STATE OF MARYLAND
DEPARTMENT OF TRANSPORTATION
STATE HIGHWAY ADMINISTRATION
OFFICE OF TRAFFIC & SAFETY
TRAFFIC ENGINEERING DESIGN DIVISION

MD 193 @ CUNNINGHAM DR/
BELTWAY PLAZA ENT

TRAFFIC SIGNAL PLAN

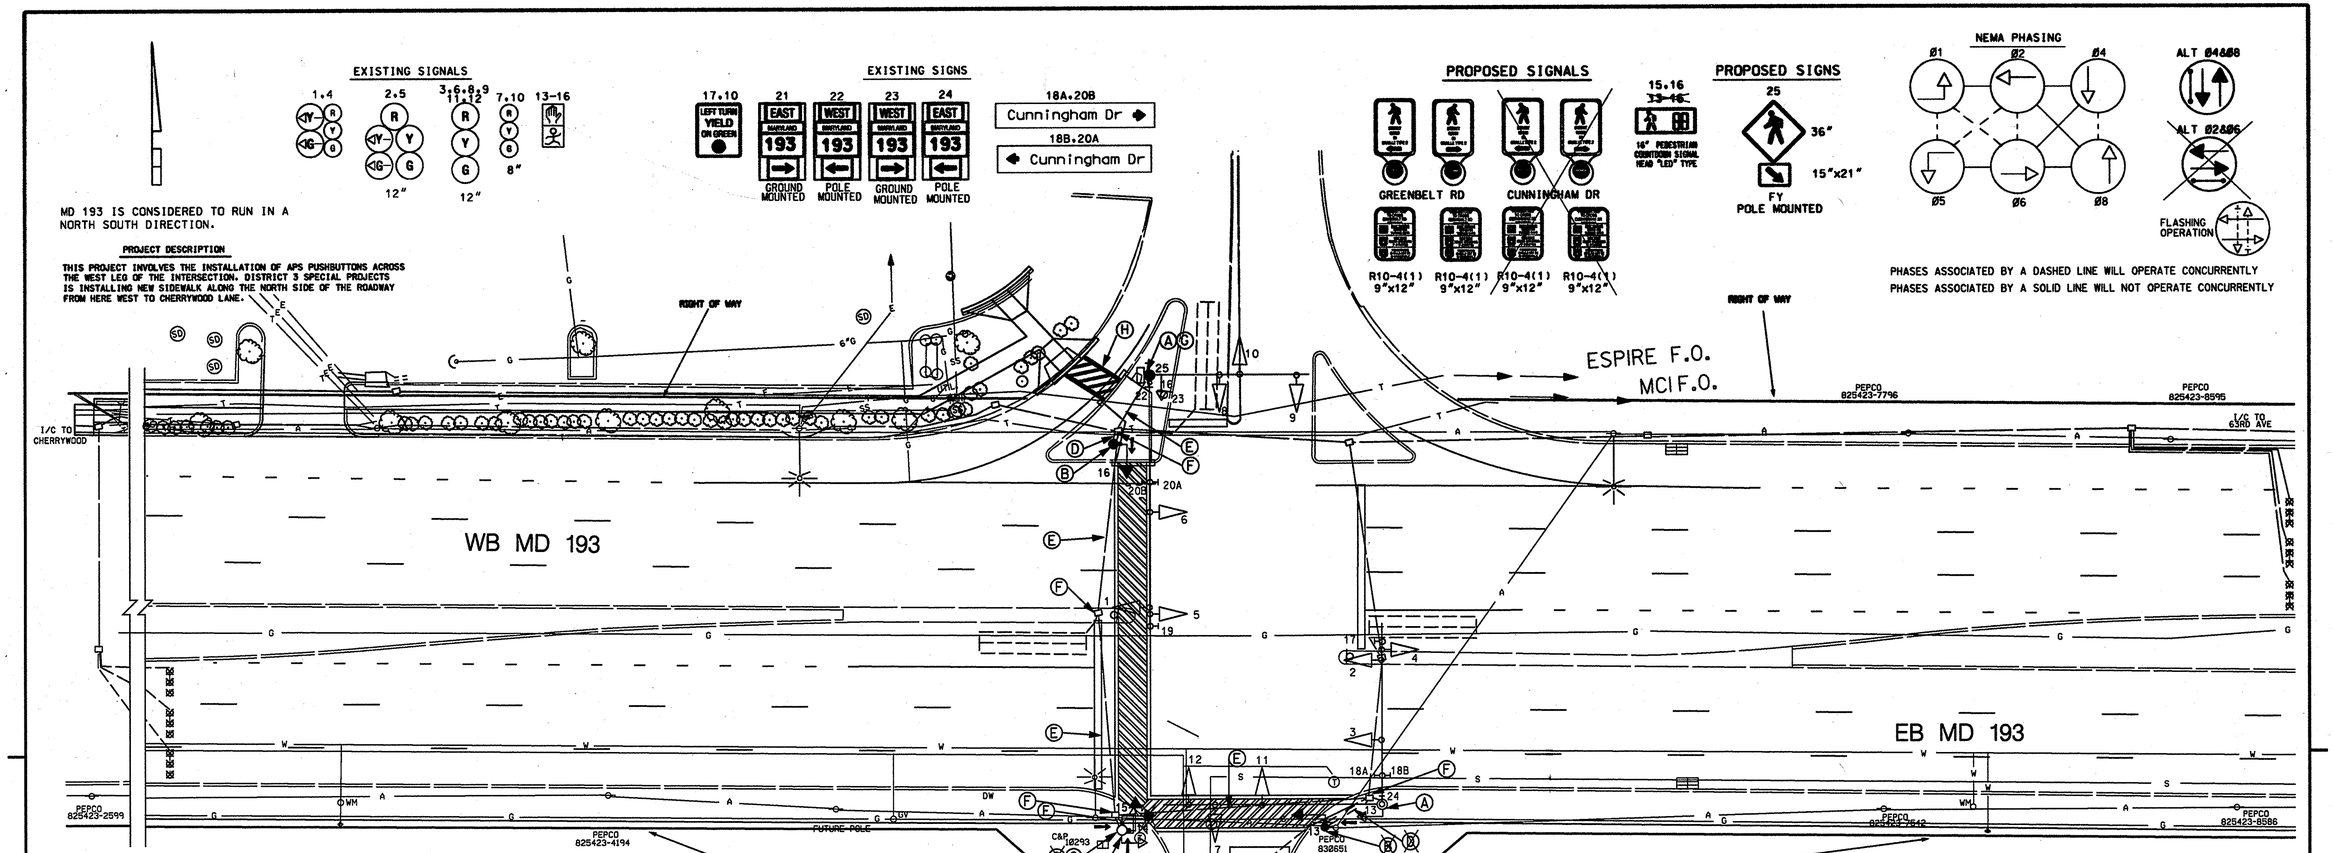
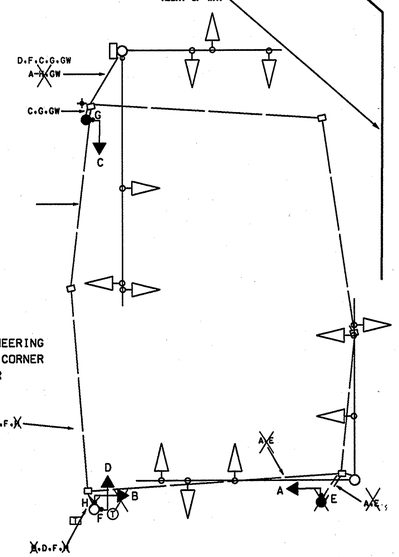
ITEM #	QUANTITY	ITEM DESCRIPTION
1001	1 EA	MAINTENANCE OF TRAFFIC
2002	2 CY	TEST PIT EXCAVATION
5004	60 LF	F&I 12" WHITE PREFORMED THERMOPLASTIC PAVEMENT MARKING
8006	1 EA	F&I 2 WIRE CENTRAL CONTROL UNIT
8014	2 EA ~~4 EA~~	F&I AUDIBLE/TACTILE PEDESTRIAN PUSHBUTTON STATION AND SIGNS
8015	1 EA ~~2 EA~~	F&I BREAKAWAY PEDESTAL POLE (ANY SIZE)
8024	2 EA ~~4 EA~~	F&I LED 16" COUNTDOWN PEDESTRIAN SIGNAL HEAD
8028	1 EA	REMOVE AND DISPOSE OF EXISTING EQUIPMENT PER ASSIGNMENT
8031	20 LF	2" SCH 80 RIGID PVC CONDUIT-TRENCHED
8040	2 CY	F&I CONCRETE FOR SIGNAL FOUNDATION
8043	~~45 LF~~	#6 STRANDED BARE COPPER GROUND WIRE
8070	1 EA	F&I GROUND ROD-3/4" DIAMETER X 10' LENGTH
8076	~~425 LF~~	F&I ELECTRICAL CABLE 2-CONDUCTOR (NO 14AWG) 40 LF
8078	~~575 LF~~	F&I ELECTRICAL CABLE 5-CONDUCTOR (NO 14AWG) 225 LF
8064	11.25 SF	INSTALL OVERHEAD SIGN

C,D ~~A~~ D 5-CONDUCTOR #14AWG
~~X~~,G,~~X~~ 2-CONDUCTOR #14AWG
F USE EXISTING 2-CONDUCTOR #14AWG
GW #6 STRANDED BARE COPPER GROUND WIRE

A UPGRADE PED INDICATIONS TO APS ON SOUTH AND WEST LEGS FOR DISTRICT SW PROJECT G674 AT7825185 9/2006 CJS

B REMOVE SOUTH LEG BUTTONS AND INDICATIONS G674 AT7825185 9/2006 CJS MAR 3/17/06
